BID NO. 16MOT26- EXTERIOR PAINTING AT WASHINGTON ELEMENTARY SCHOOL

April 10, 2026

Addendum No. 1

SHEET NUMBER: A10.1
SHEET TITLE:

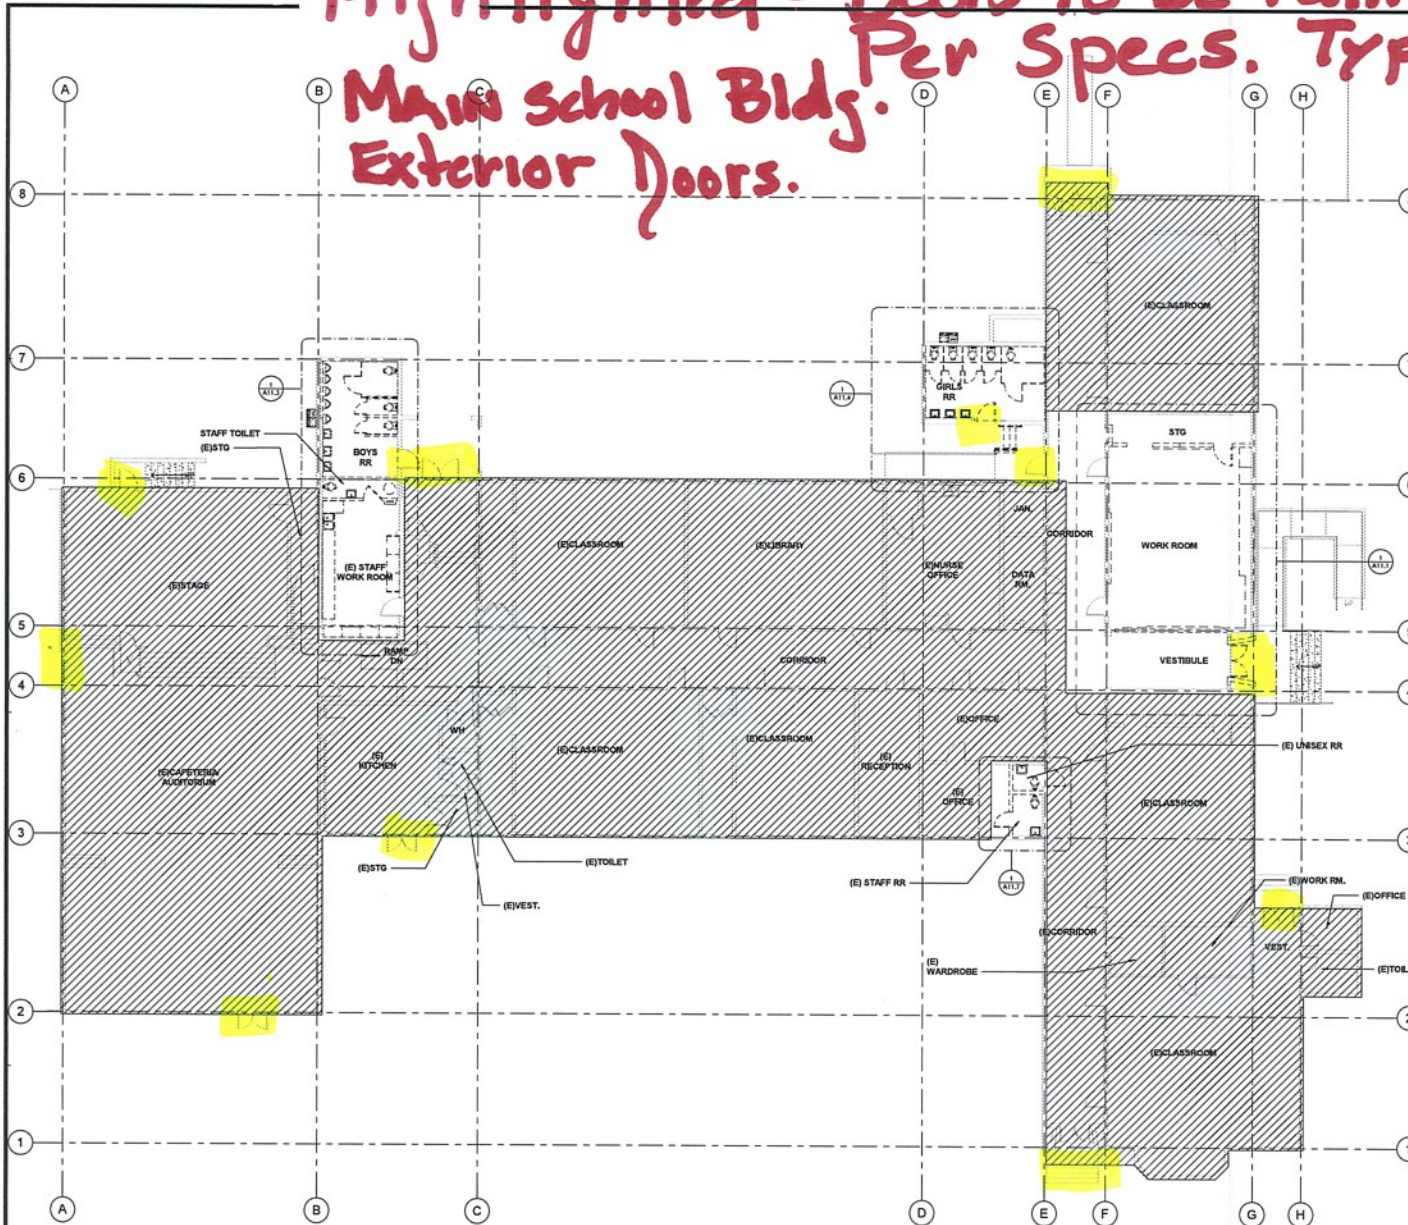
3f) Can you provide a floor plan which outlines the interior of the corridors which need to be painted interior? **See two attachments: id doors at main building and 2-Story buildings.**

Highlighted - Doors to be Painted
Per Specs. Typ
Main School Bldg.
Exterior Doors.
